DFCM Addendum #3

Reference: Bastian Equestrian Arena
DFCM Project #25401770
U3P Event #CS25039-Stage II

ADDENDUM NO. 1
April 14, 2025

USU Bastian Equestrian Arena

DOOR FRAME TYPES

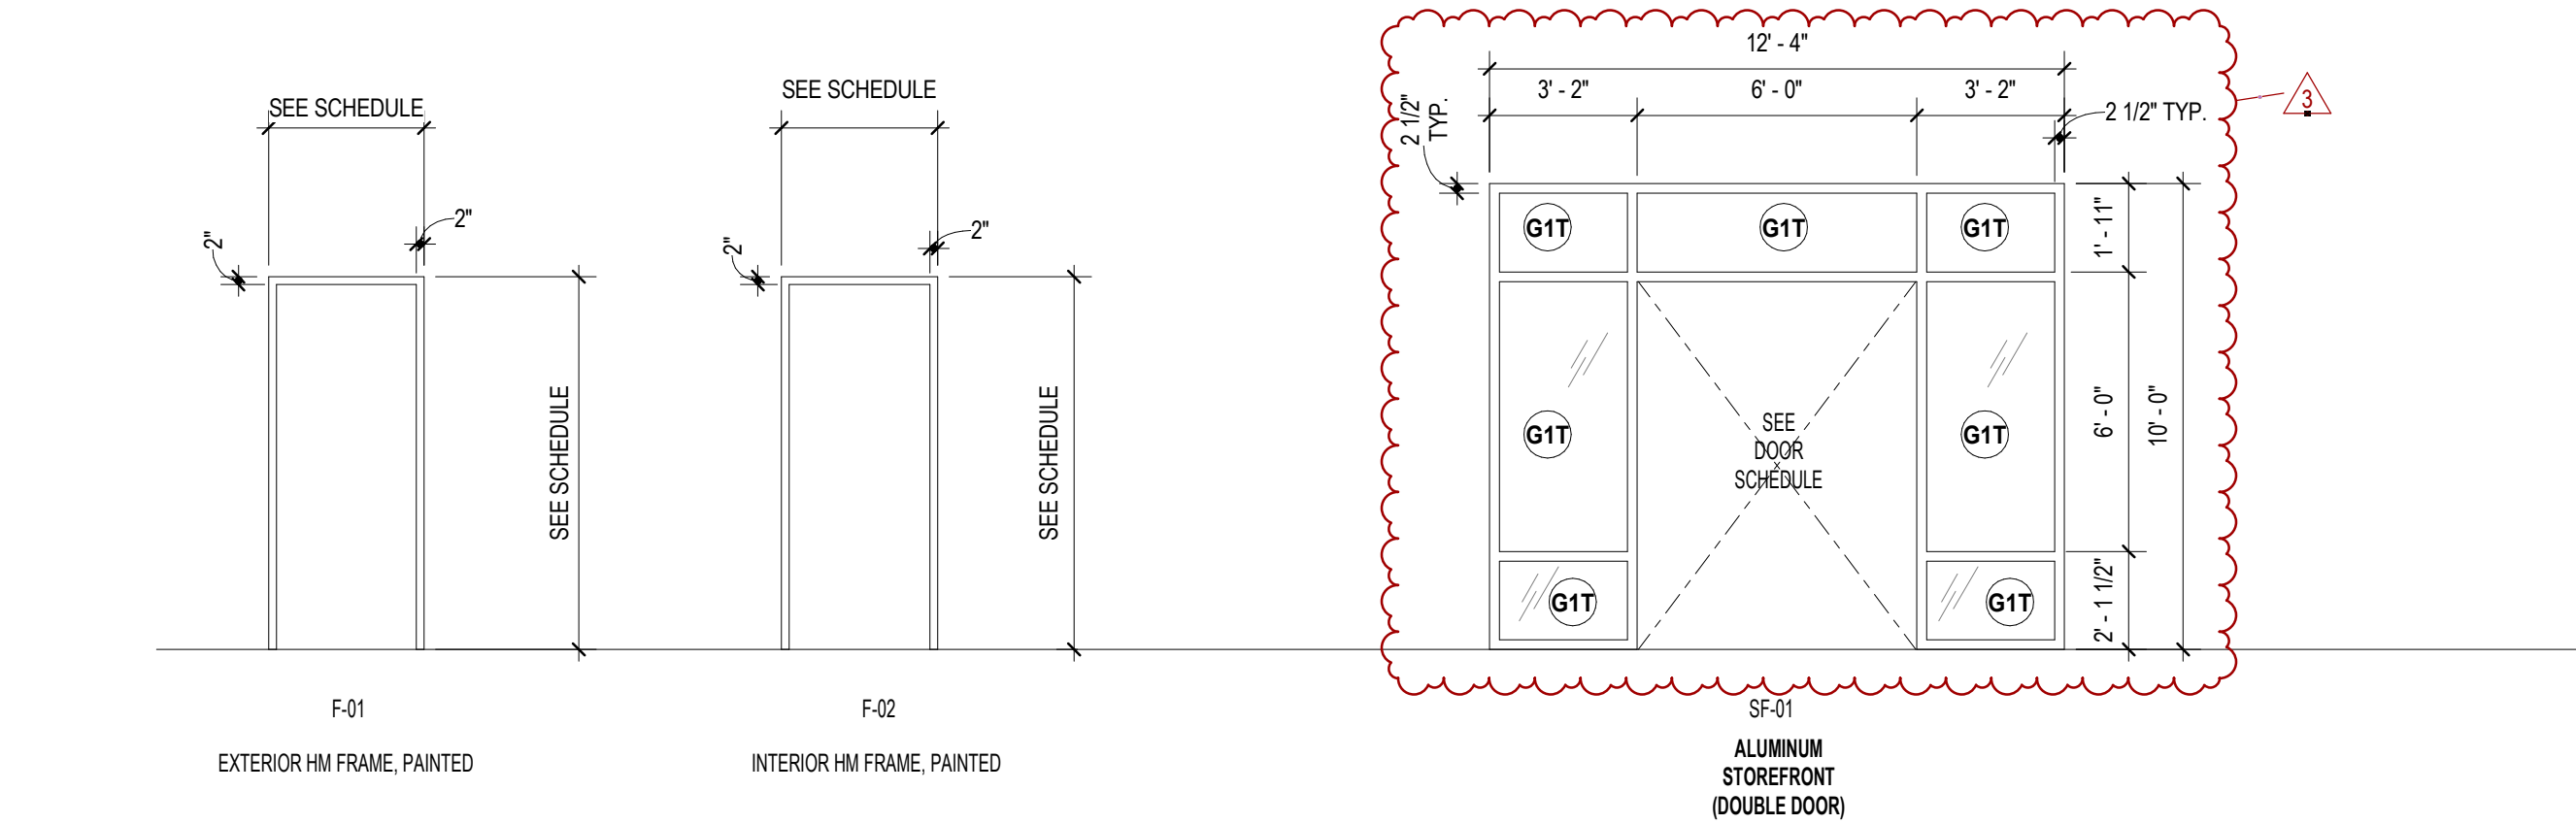
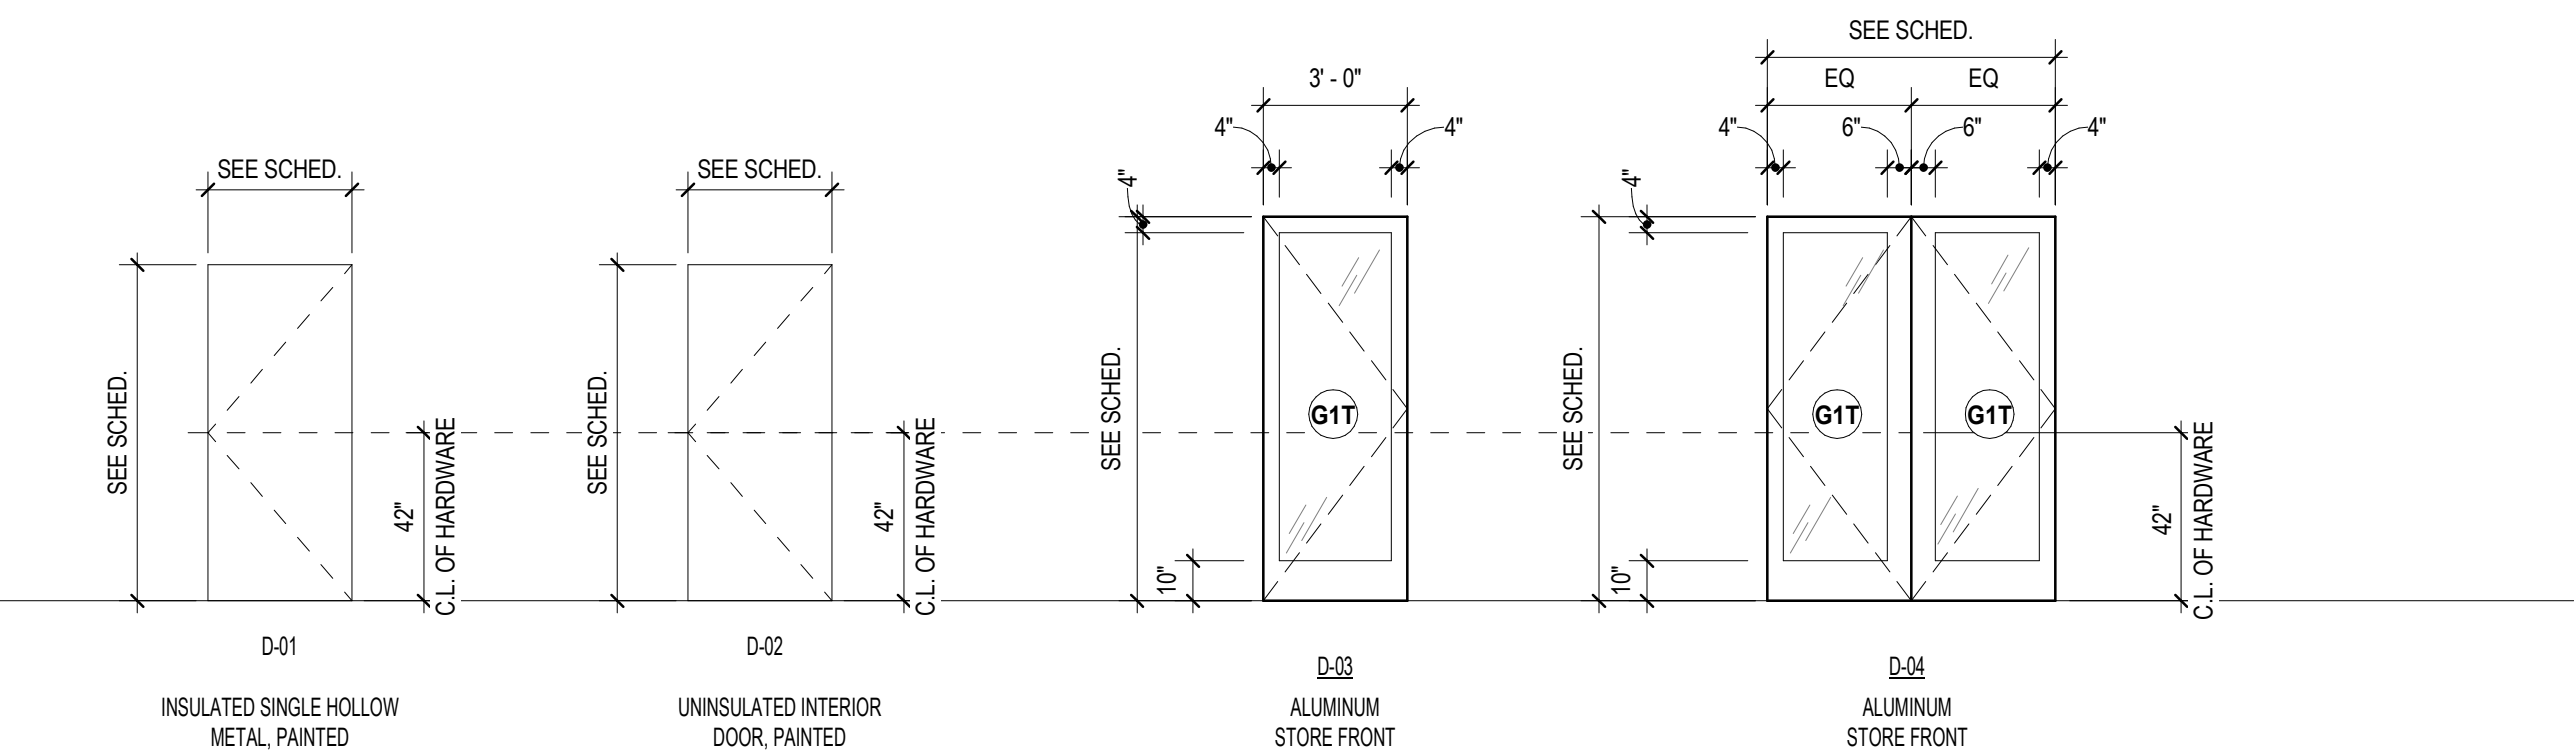
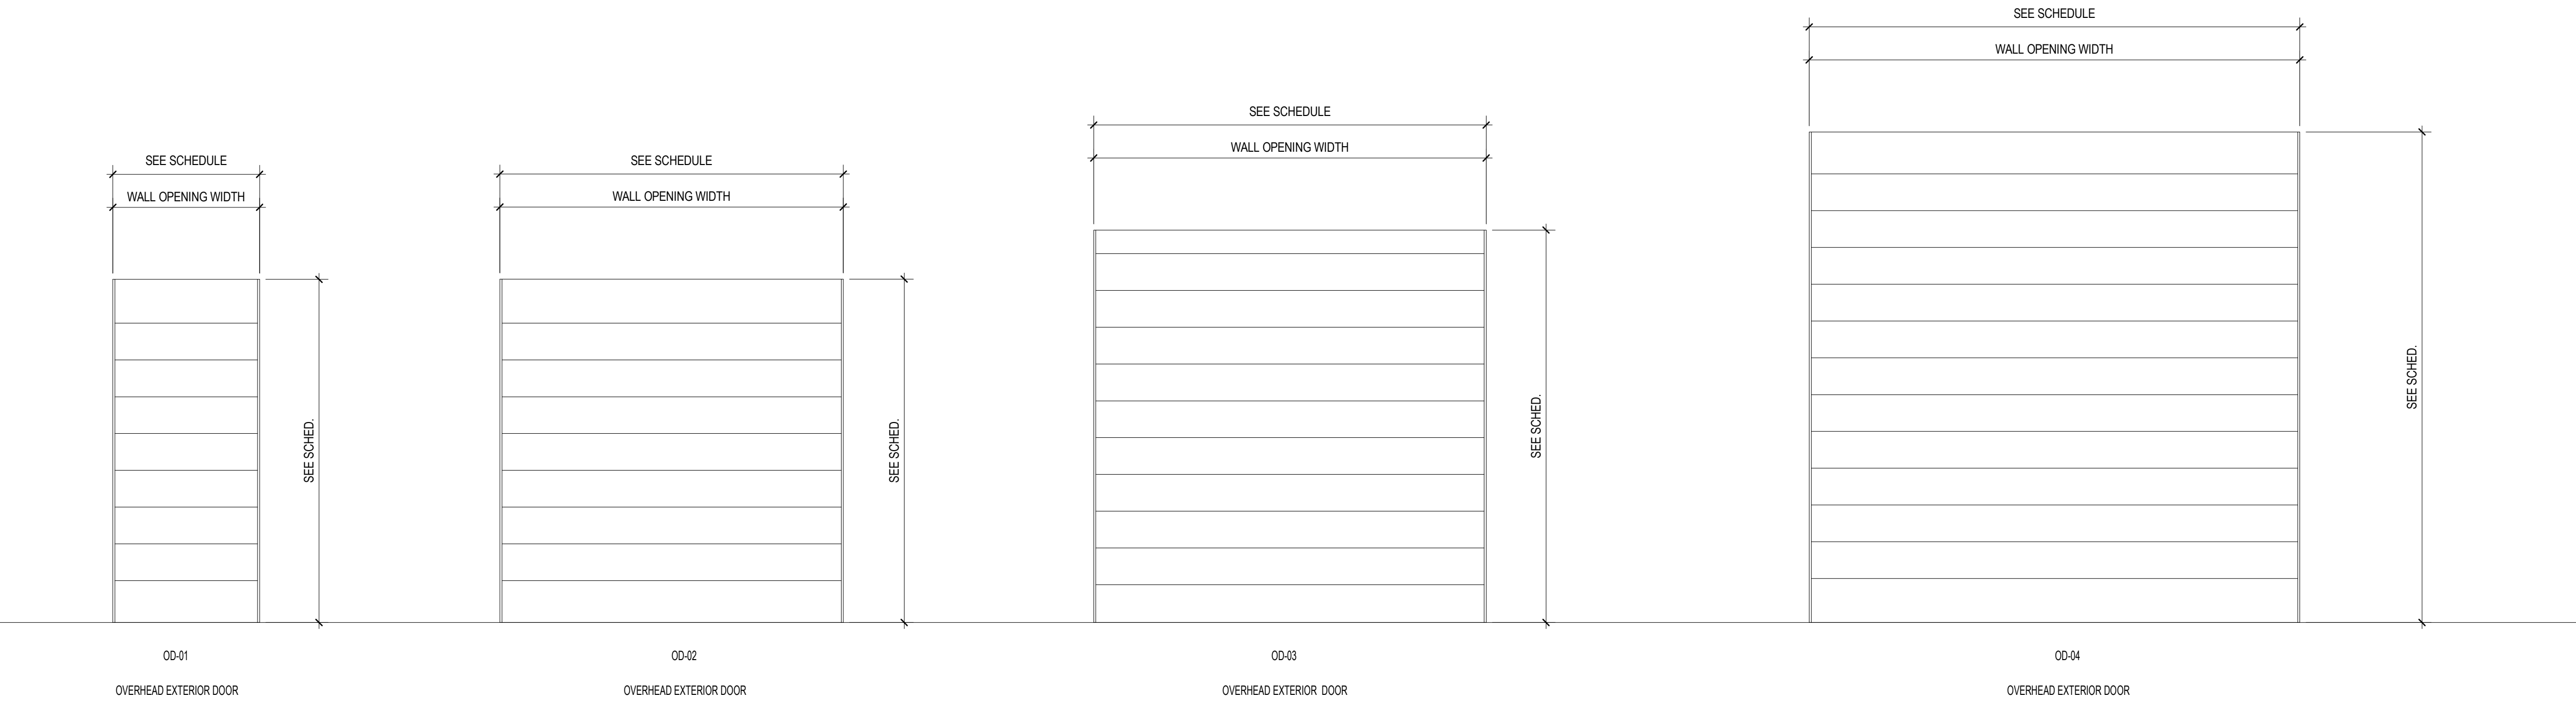
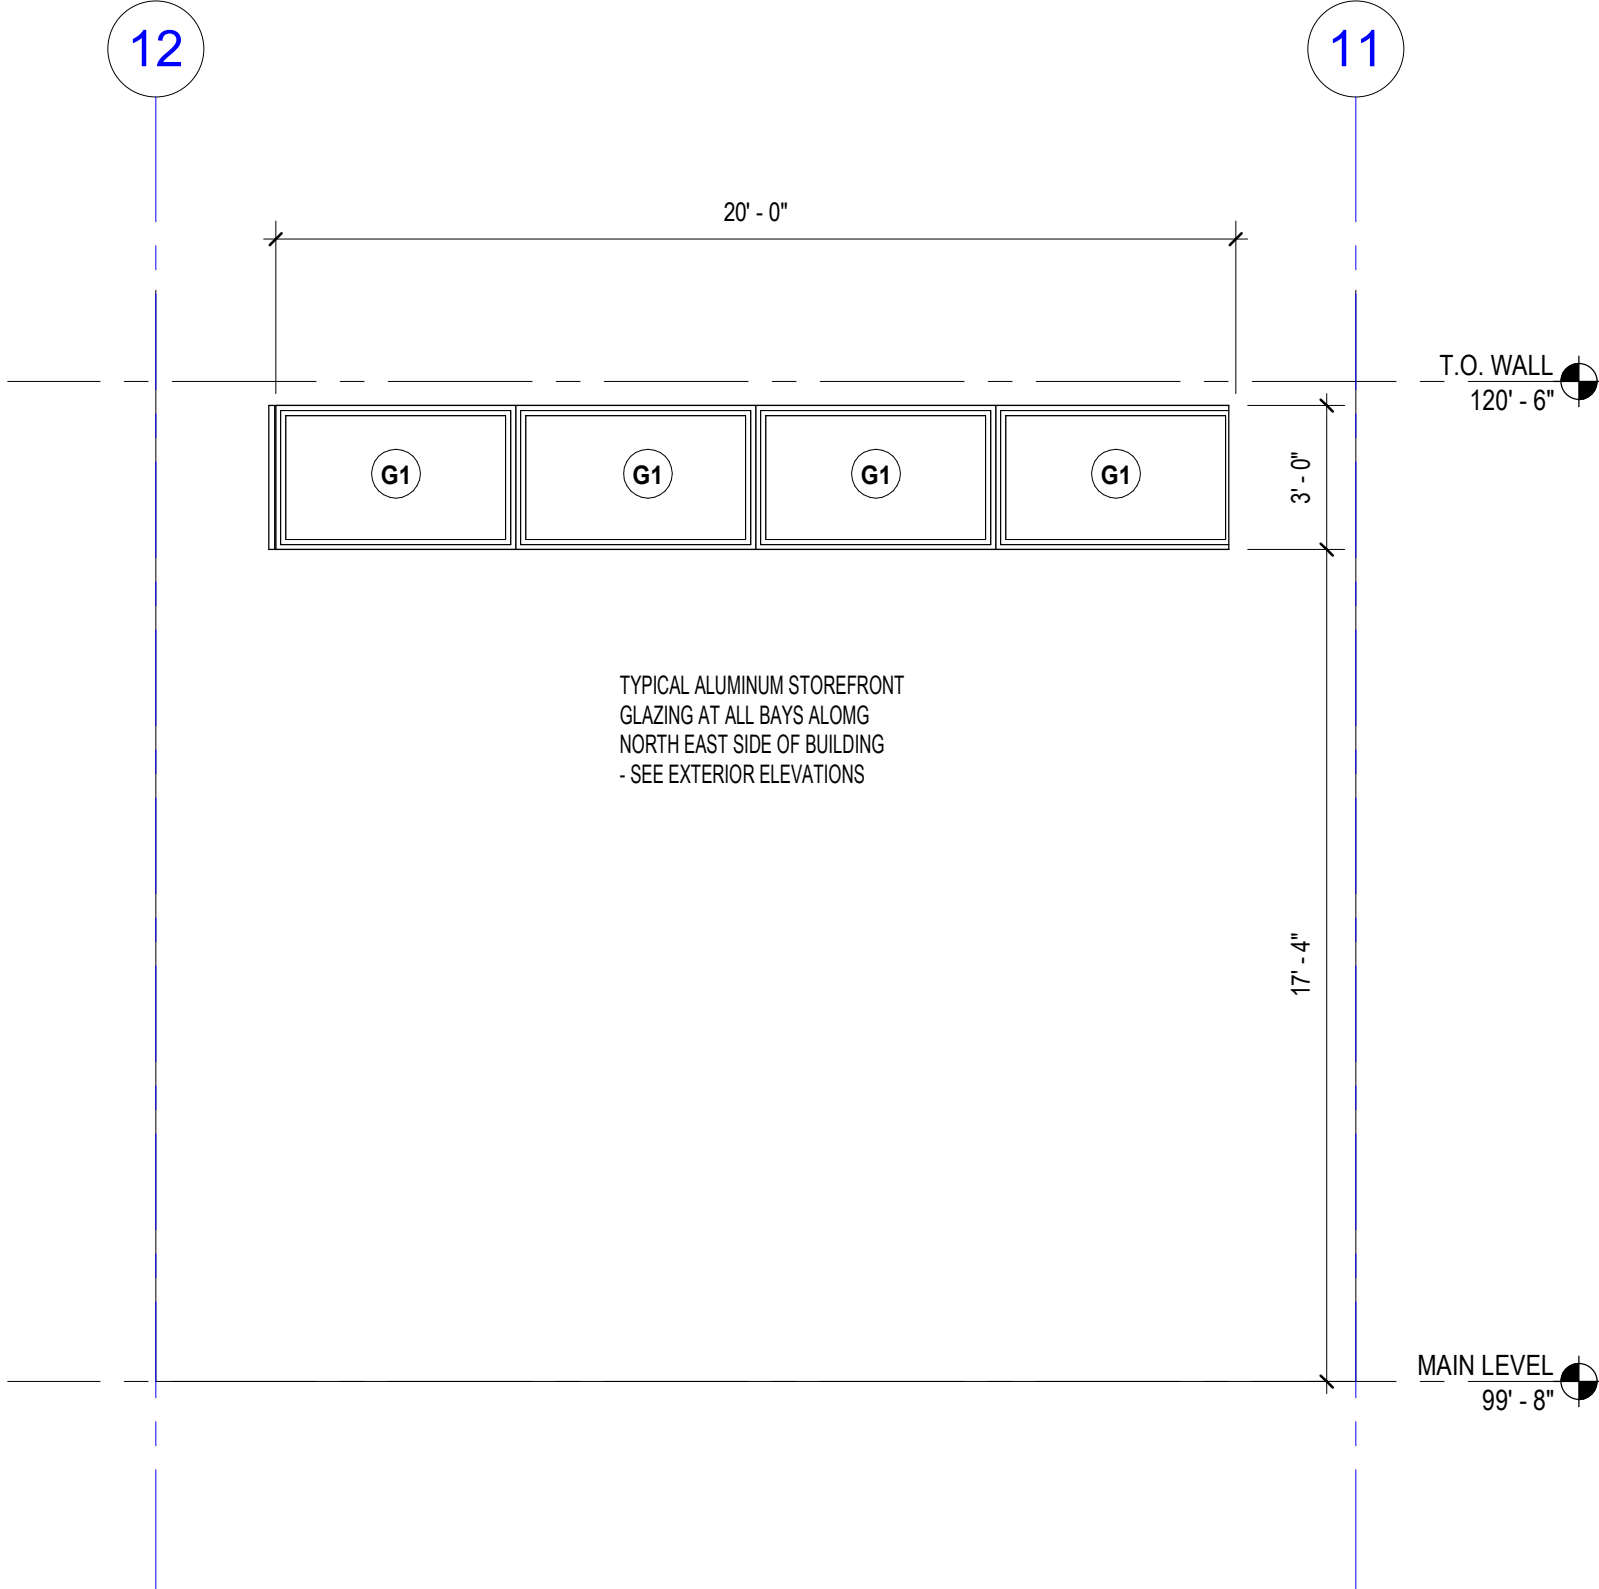
Question 010 - A601 – Verify whether or not overhead doors are insulated

Question 011 - A601 – D1 door frame types, aluminum storefront: notes for tempered glass need to be relocated to glass.

Response: Yes they are insulated per spec section to a minimum of 8.1 r-value.

Response: This has been corrected. Also see the modified upper portion of the storefront entry door and glass, the upper window got 12" taller. See attached A601.
